SECTION 4.55 APPLICATION
33 UPPER CLIFFORD AVENUE
LOT C DP 102834 FAIRLIGHT
DA166/2015

S4.55 APPLICATION DRAWING LIST

DEVELOPMENT CONSENT DA-166/2015
NORTHERN BEACHES COUNCIL
DEVELOPMENT MODIFICATION MOD2018/0715
BASIX CERTIFICATE No A336197_03

S4.55 APPLICATION
ADDITIONS & ALTERATIONS
33 UPPER CLIFFORD AVENUE
FAIRLIGHT

LOWER LEVEL PLAN

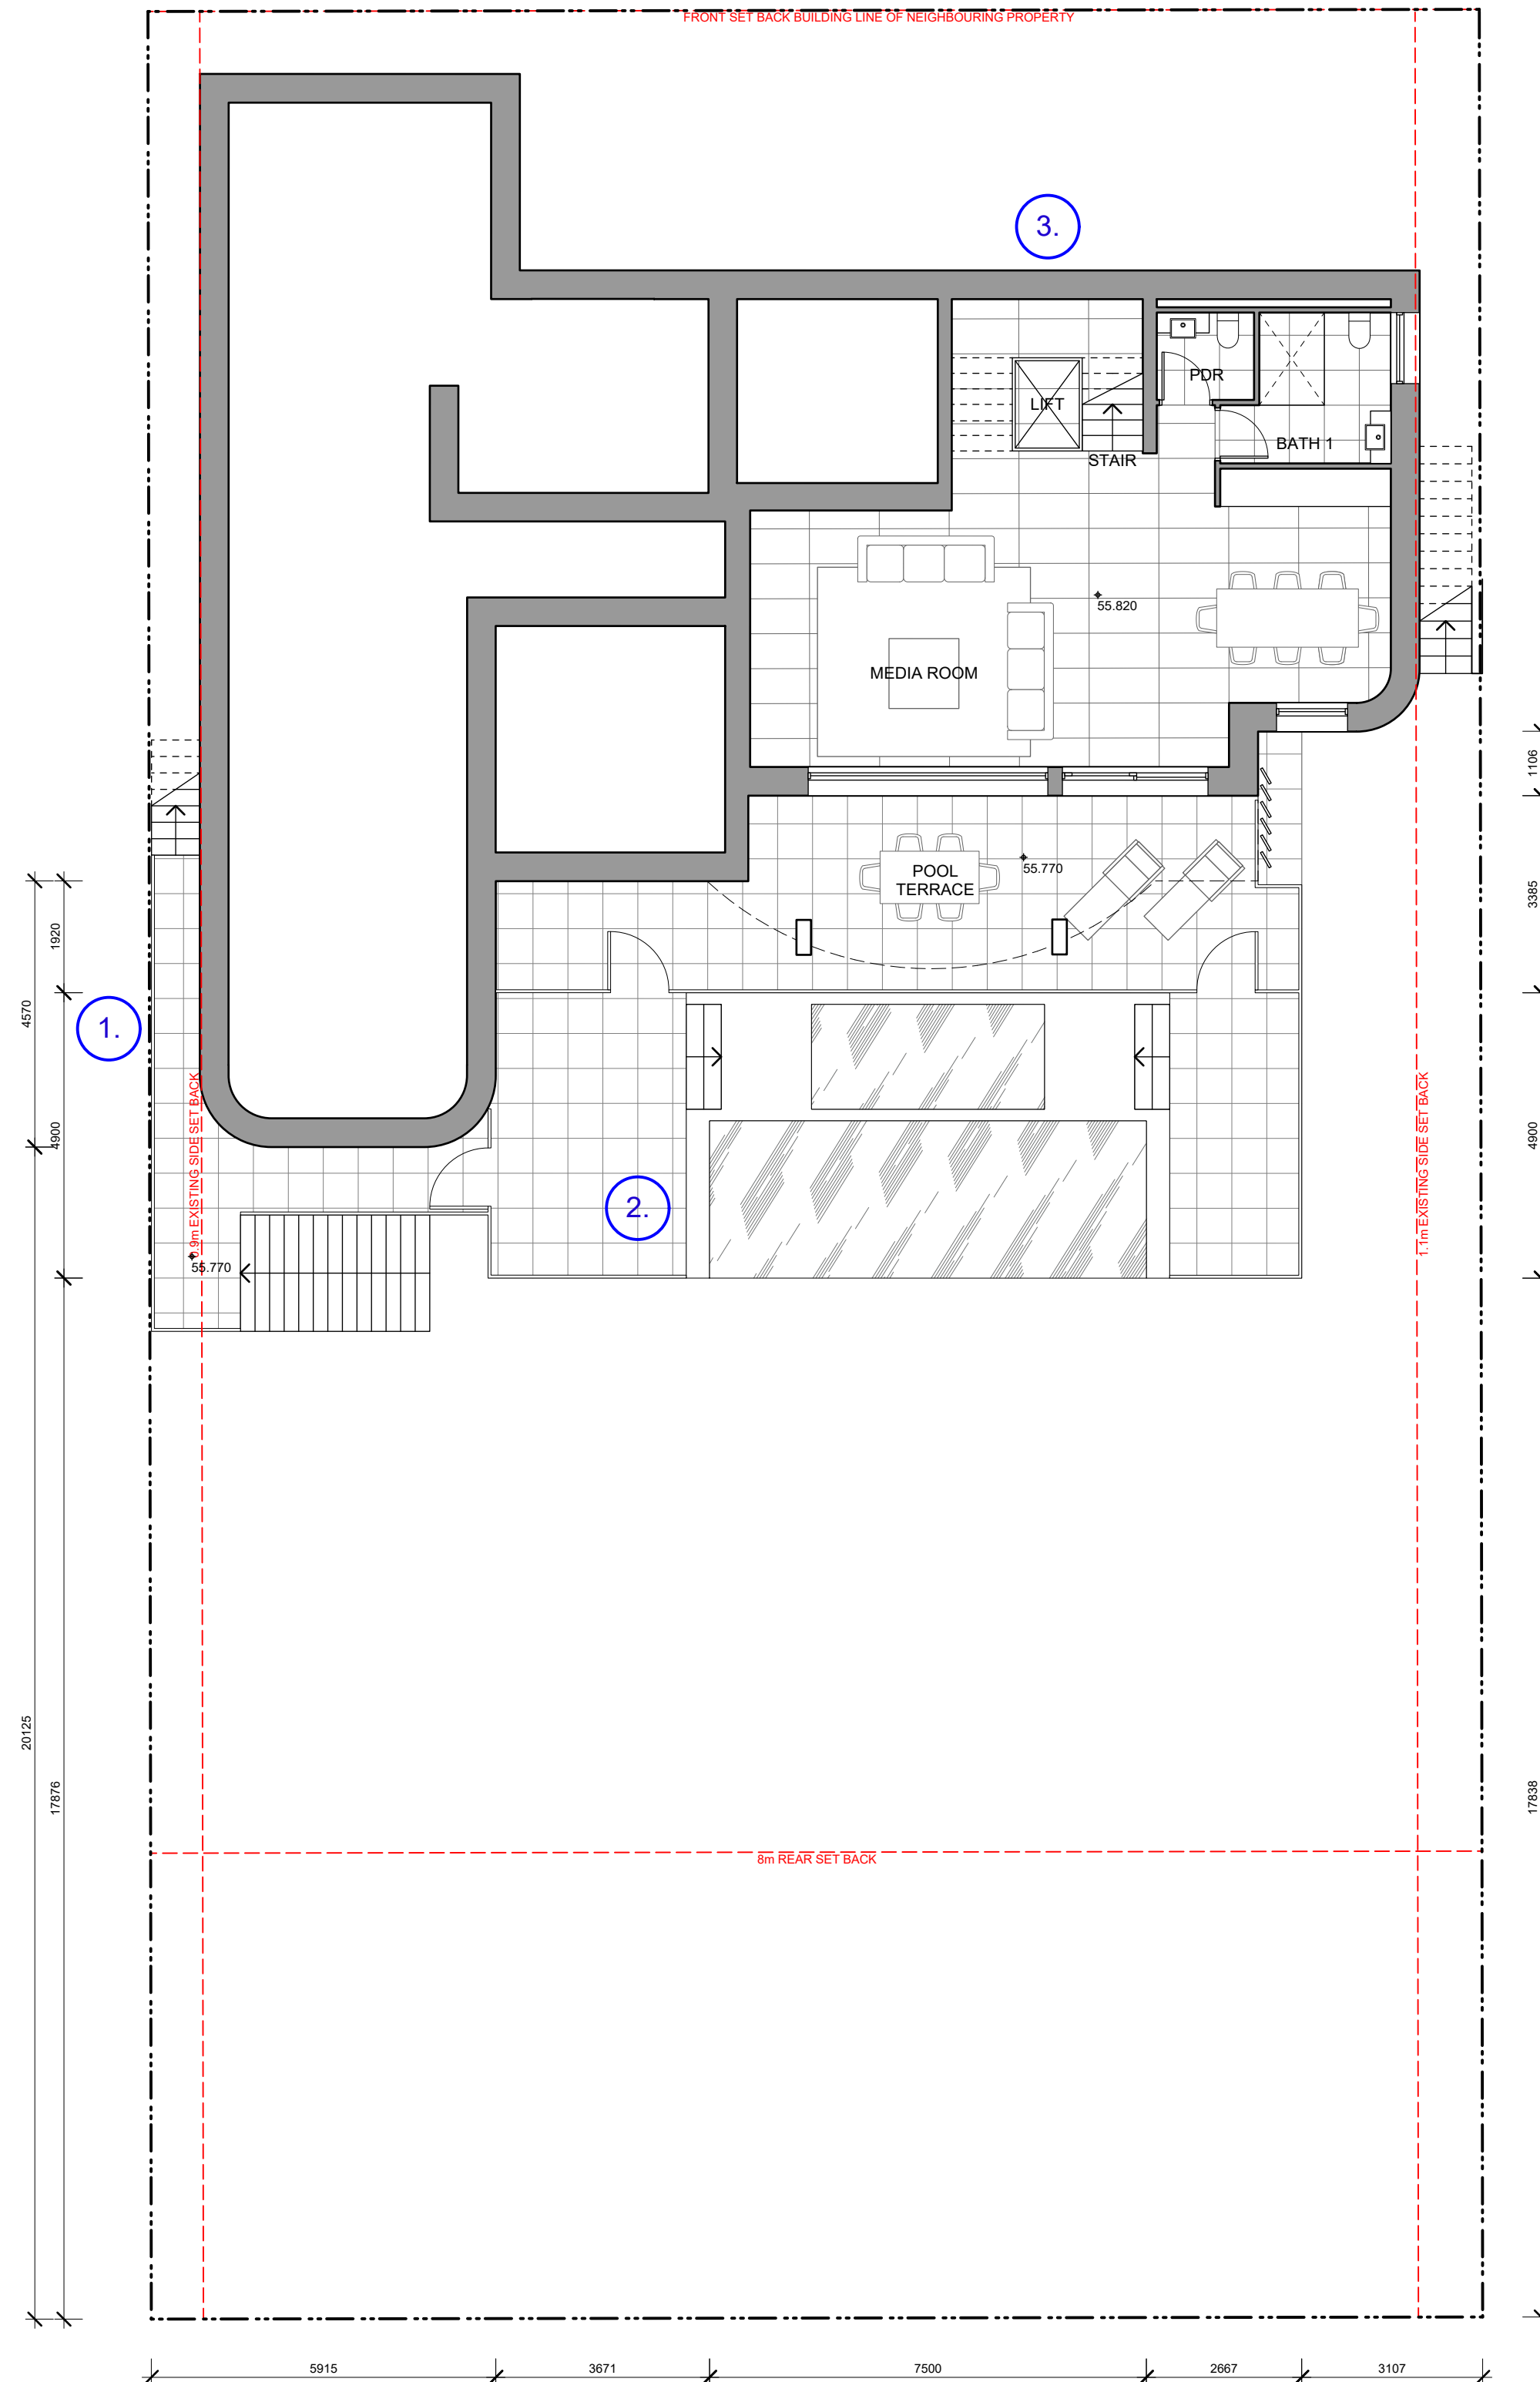
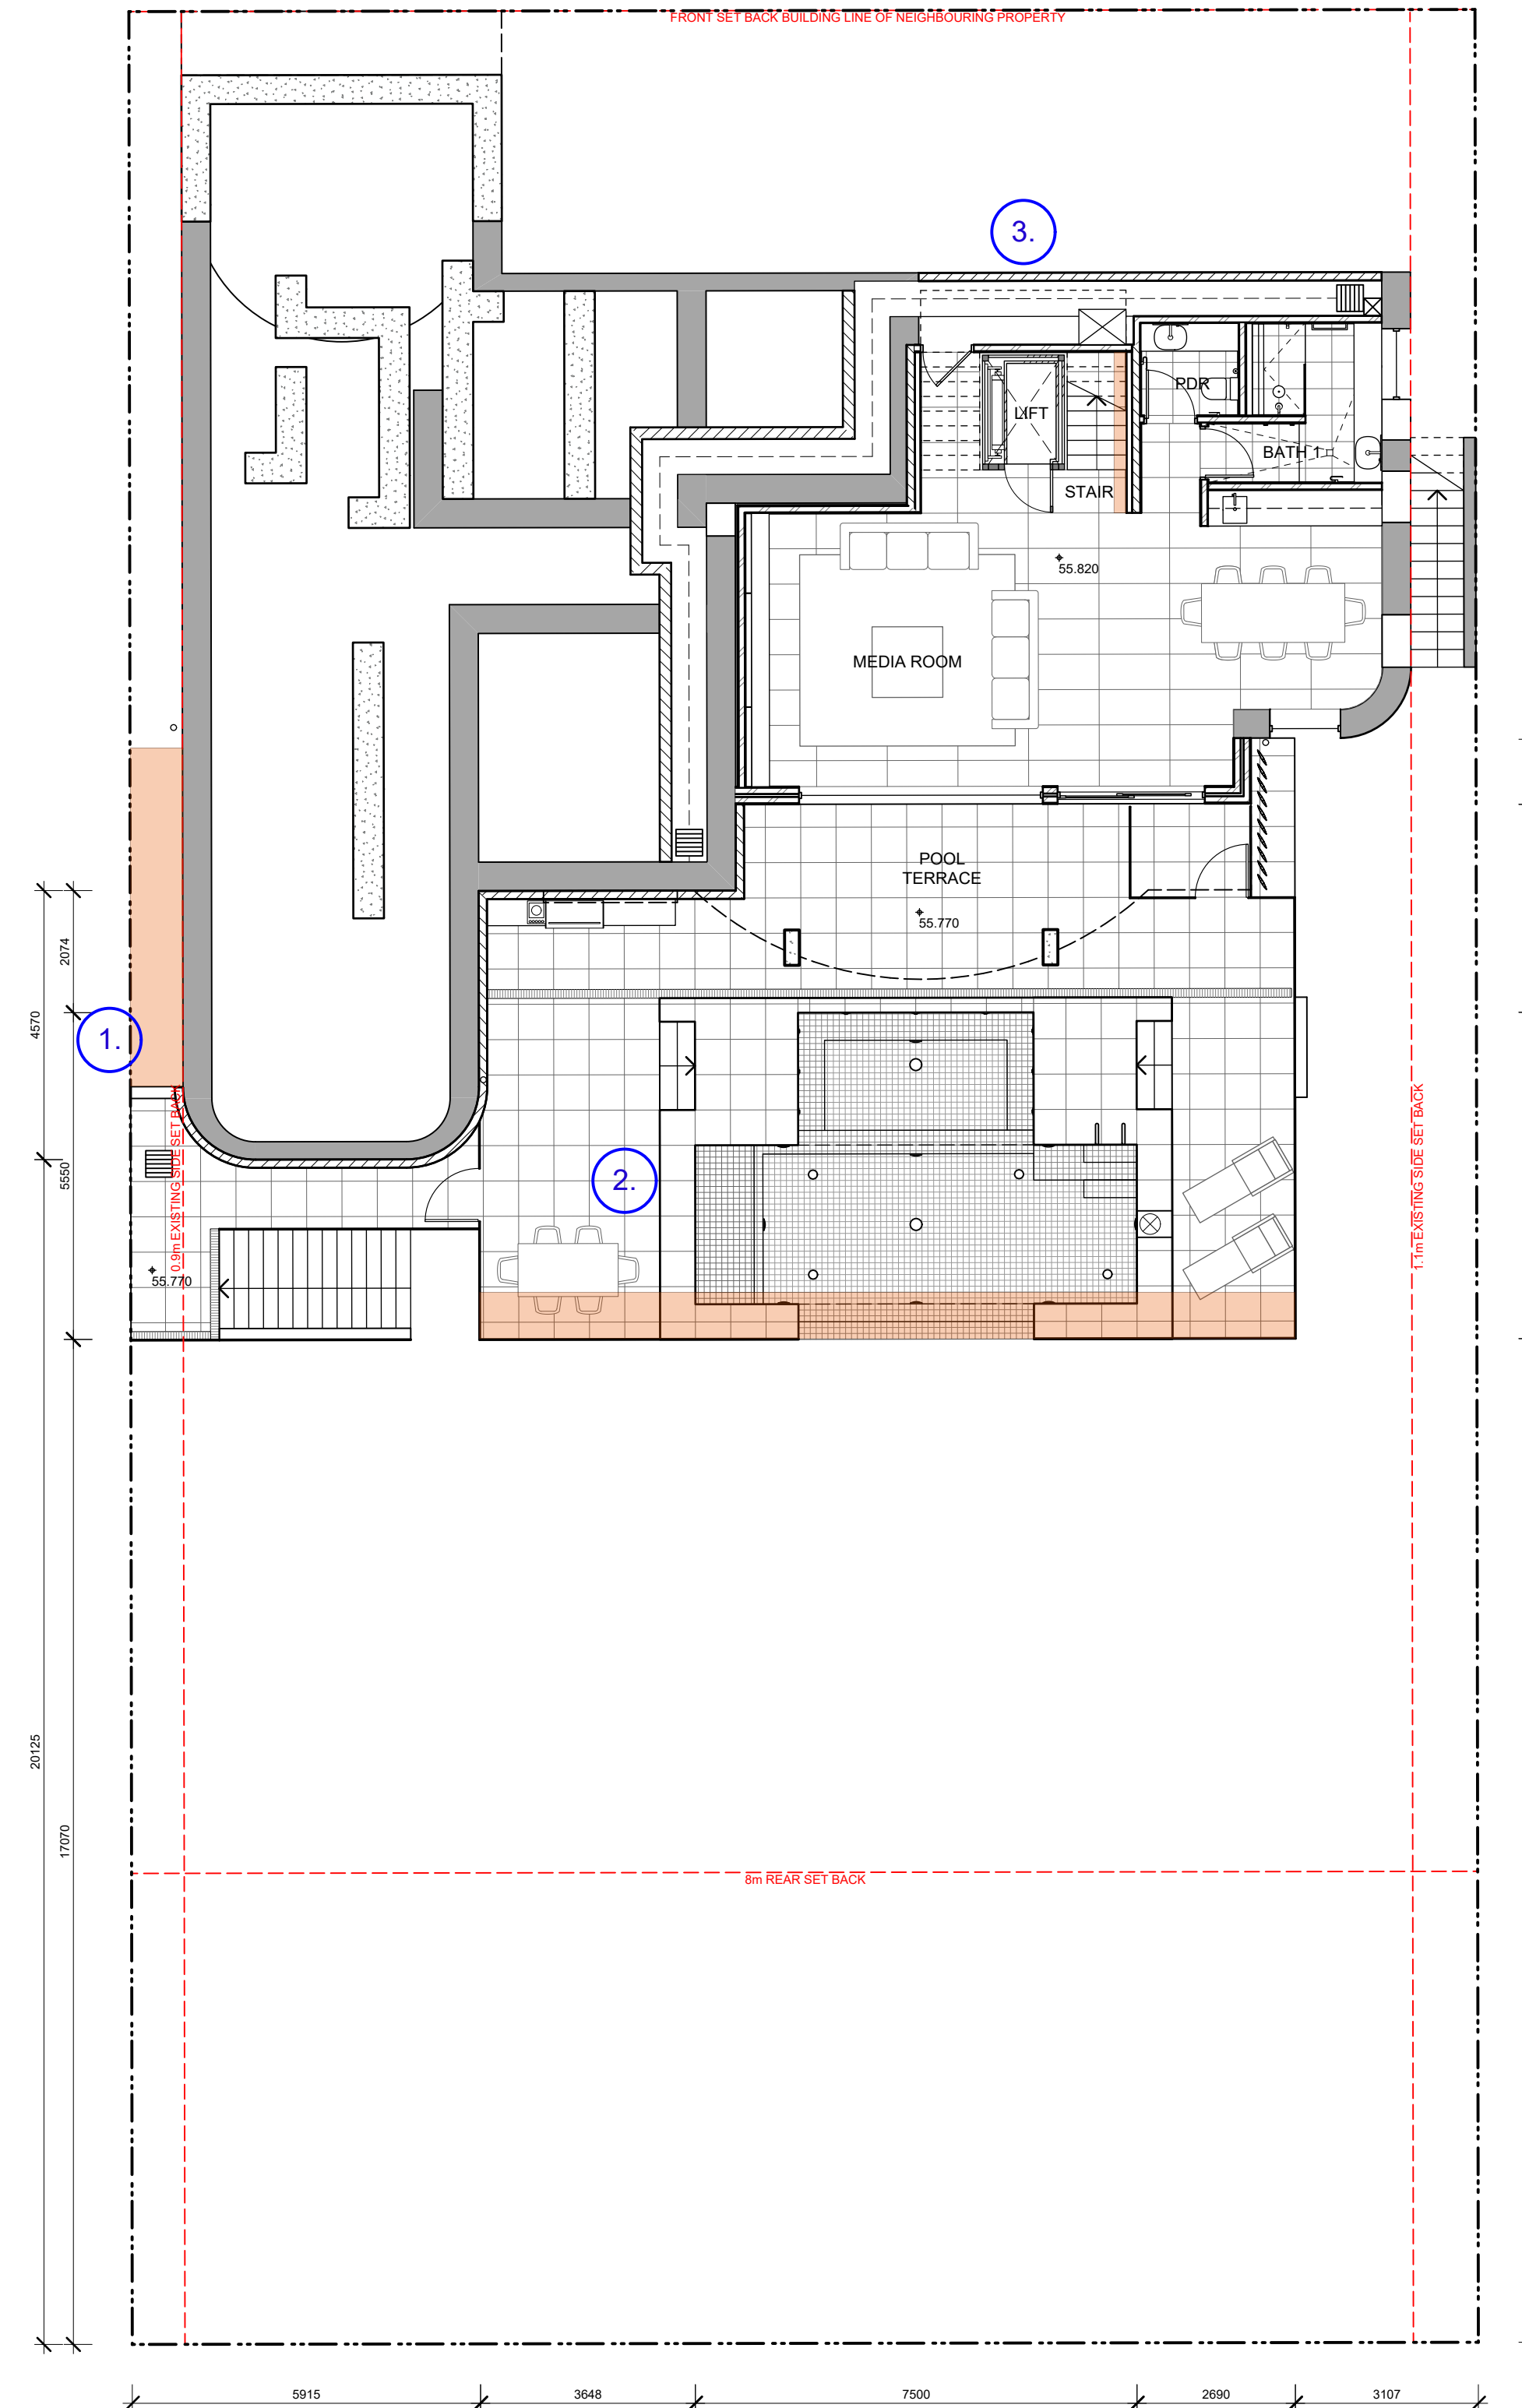
- LOWER GROUND / POOL TERRACE**
1. REMOVE WESTERN STAIR ACCESS
 2. MINOR CHANGE TO POOL TERRACE DESIGN
 3. REVISED INTERNAL STAIRCASE CONFIGURATION
